2013 General Rate Application (NSUARB P-893)
NSPI Responses to Avon Information Requests

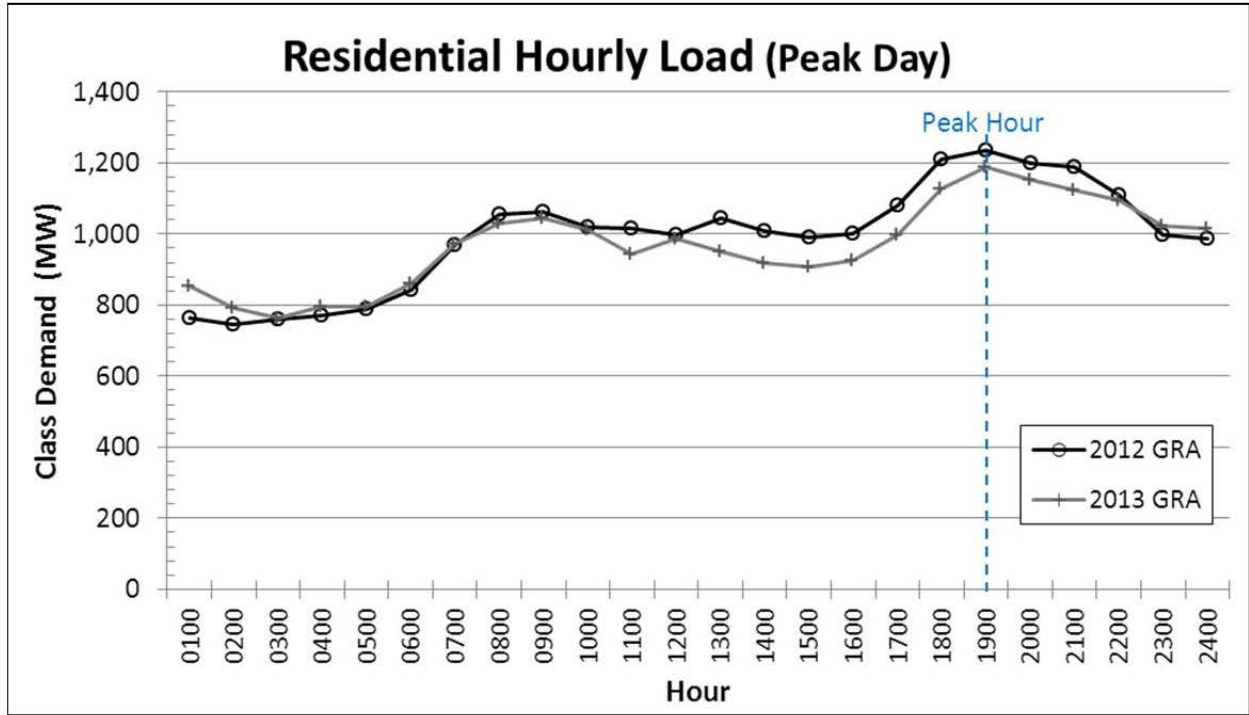
7 (b) **Does NSPI really believe that the Small General Service rate class peak**
8 **shifted to the extent depicted in the figure on pdf page 187? What other**
9 **factors could account for the change?**

1 These curves, representing an average customer in each class, are then scaled to the
2 annual class energy consumption. The hourly class curves are then aligned with the
3 hourly system load curve from the Supervisory Control and Data Acquisition (SCADA)
4 system so that their contribution to the system load can be calculated for each hour of the
5 year. Once the load and class curves are reconciled for the historic base year, they are
6 then scaled to forecast levels.

7
8 The load research sample was designed to provide a 90/10 confidence or precision level.
9 This means that 90 percent of the time, the precision of the results is within ± 10 percent
10 of actual.

11
12 (b) Customer behaviour and energy consumption is influenced by a broad array of factors.
13 The sample class curve methodology is currently the best available approach to
14 estimating class contribution to the hourly system peak. Because of the potential to have
15 unusual customer behaviour on the one annual peak day, NS Power uses the 3CP method
16 of averaging of the three winter peak days for the month of January, February and
17 December. This averaging of the three coincident peaks tends to smooth out unusual
18 patterns.

19
20 The class contribution to system peak can change from year to year for a wide variety of
21 reasons. The effects of peak day weather influence classes differently and to different
22 extents. The system peak may also occur on a different month of the year, day of the
23 week and hour of the day from one year to the next. Economic conditions and
24 conservation plans also change customer behaviour.

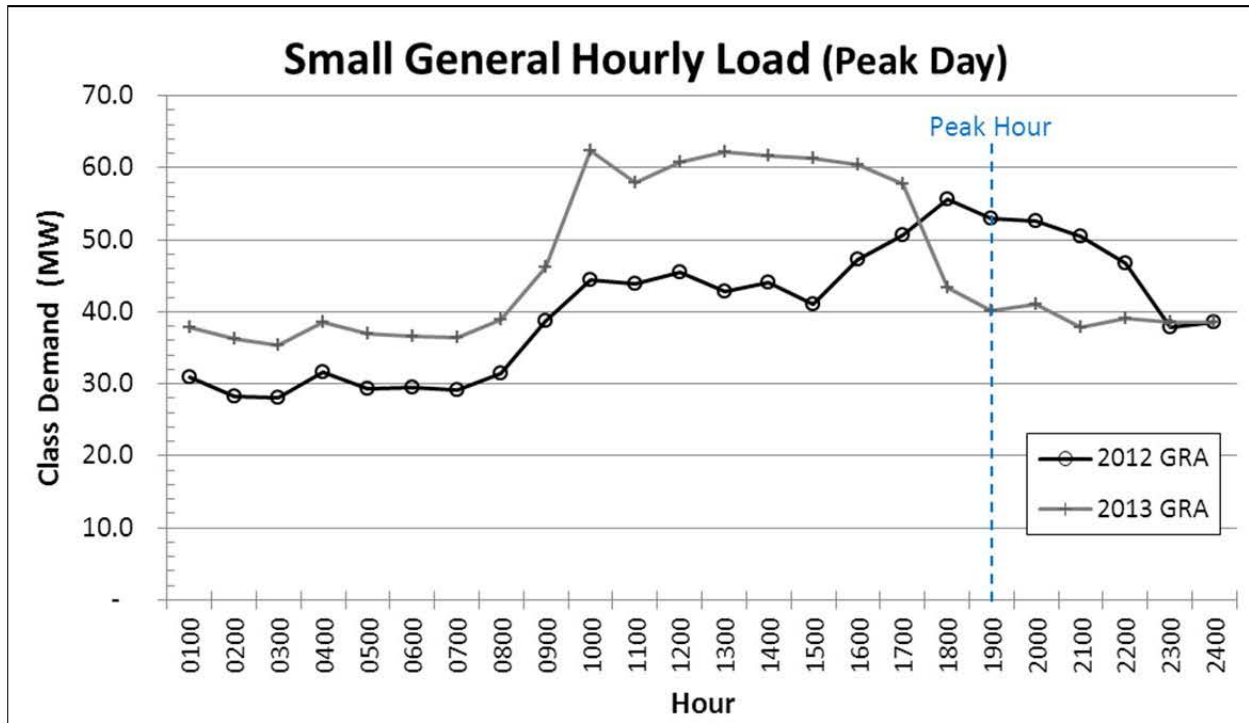
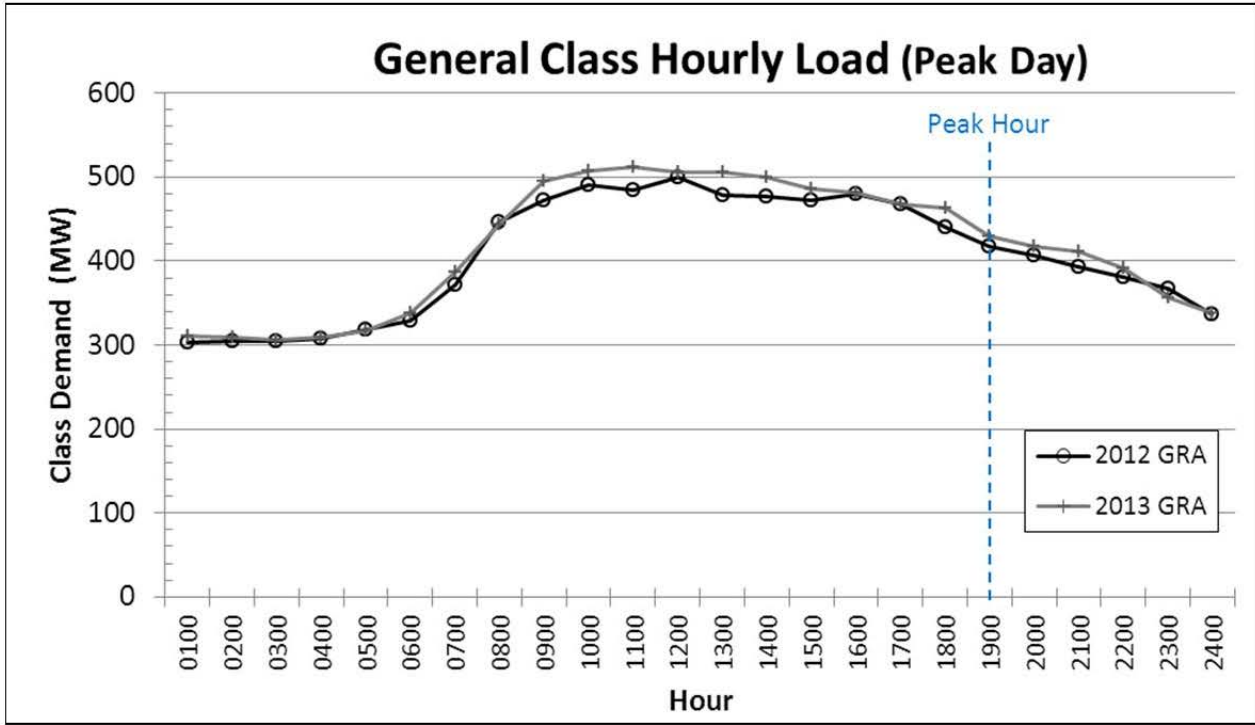
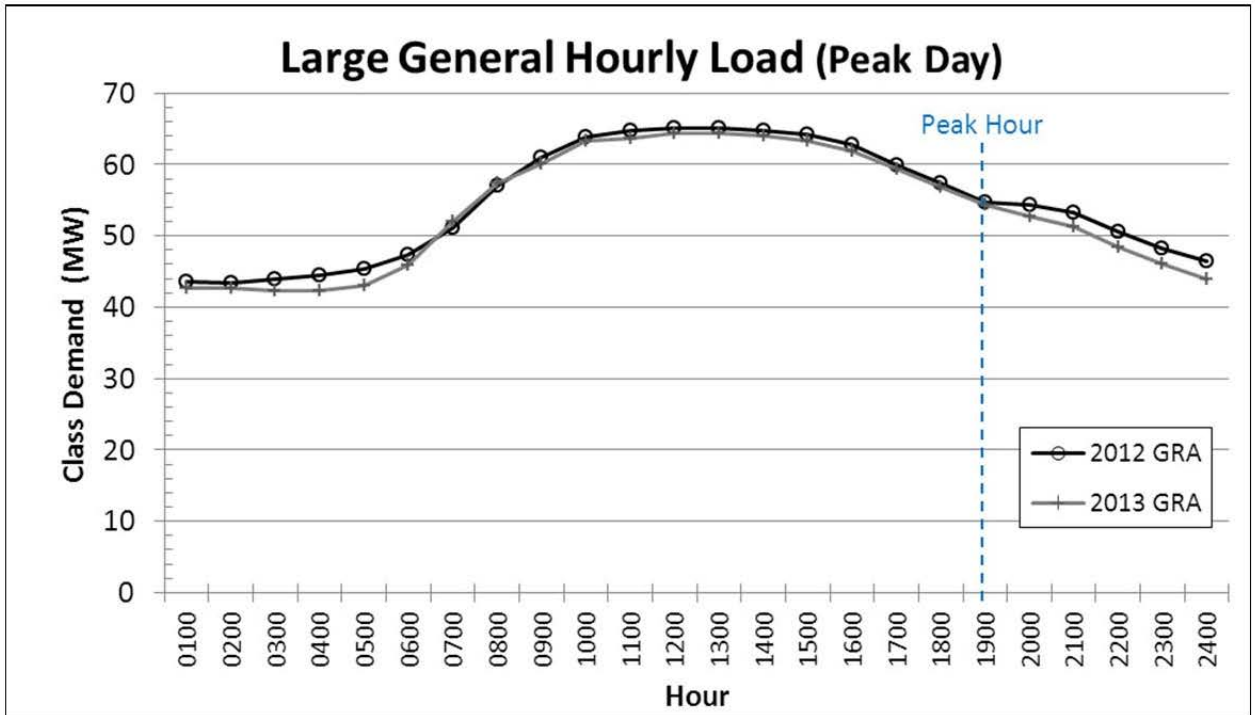
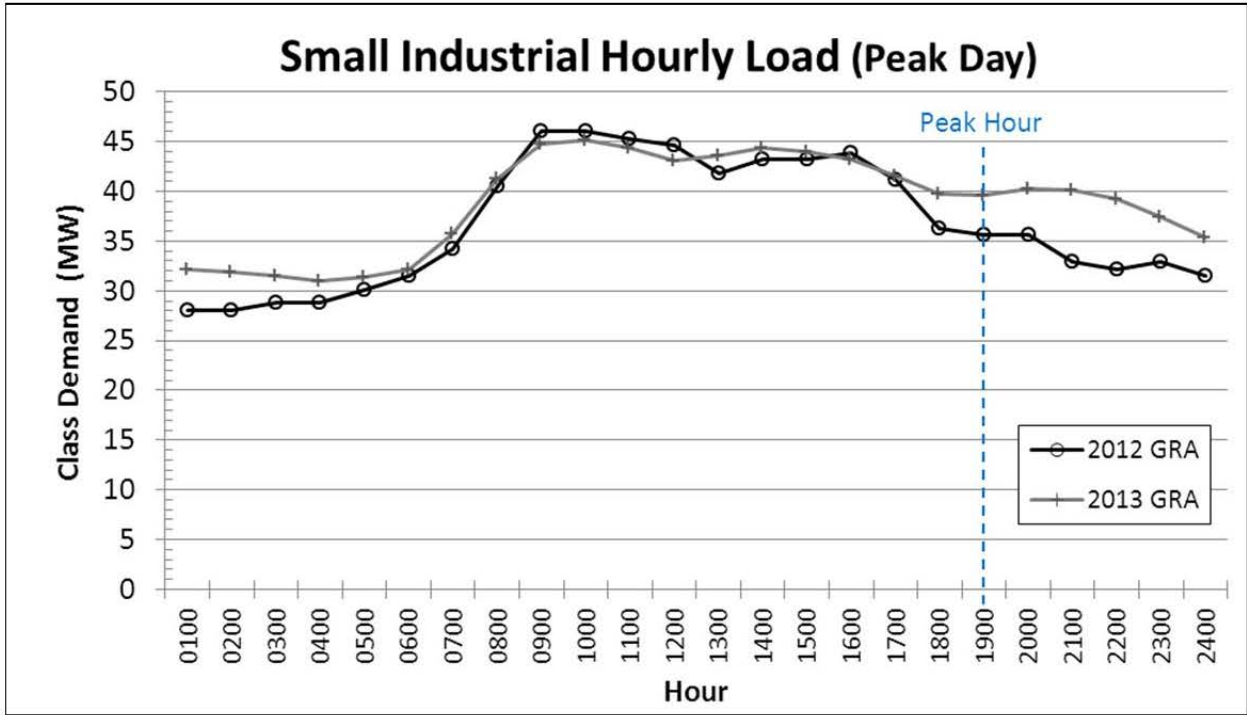
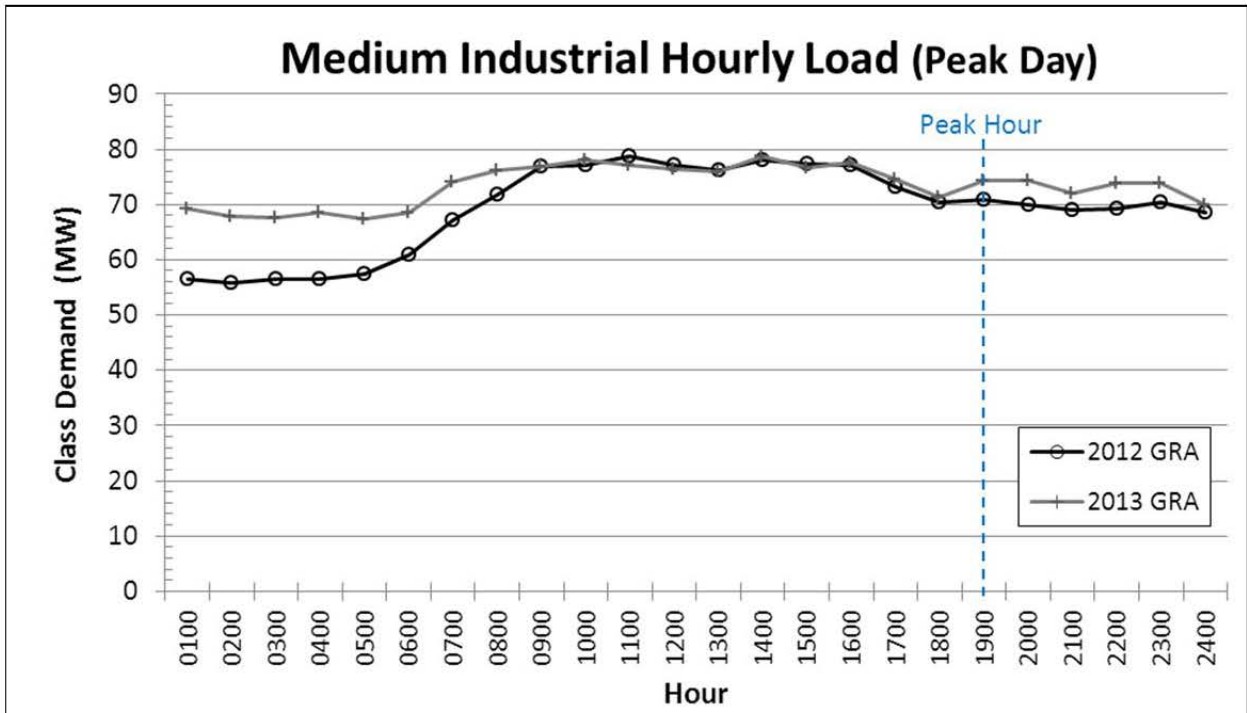
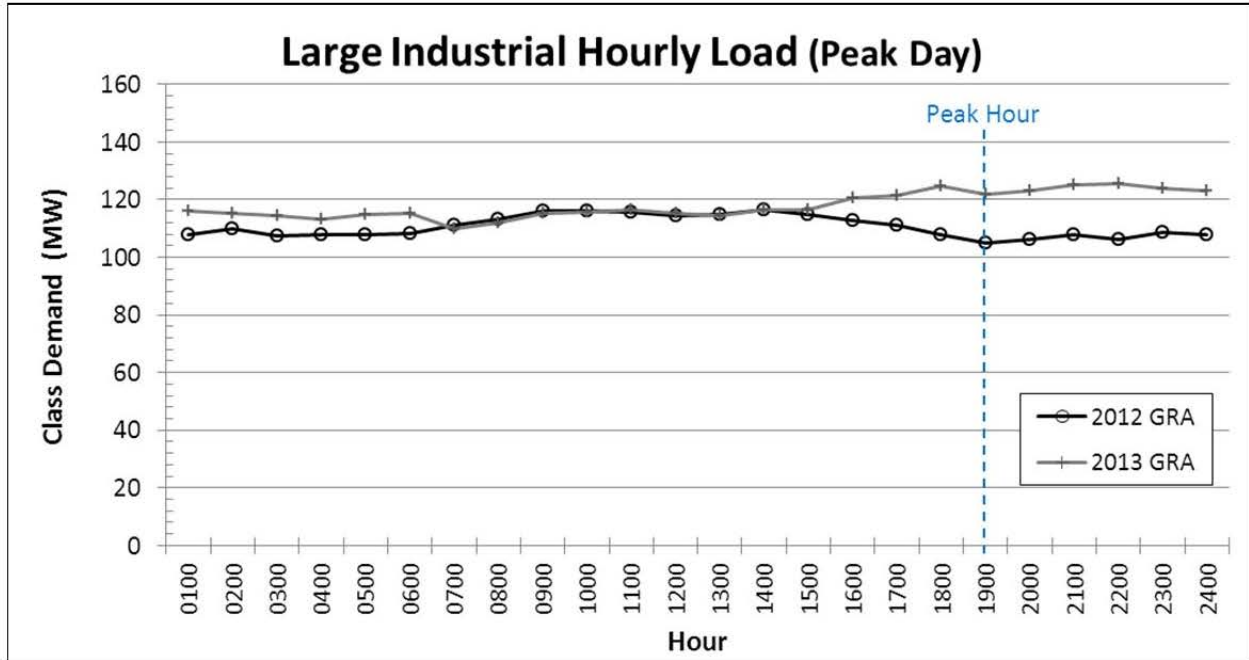
10 (c) **Please provide figures similar to that on pdf page 187 for each rate class.**
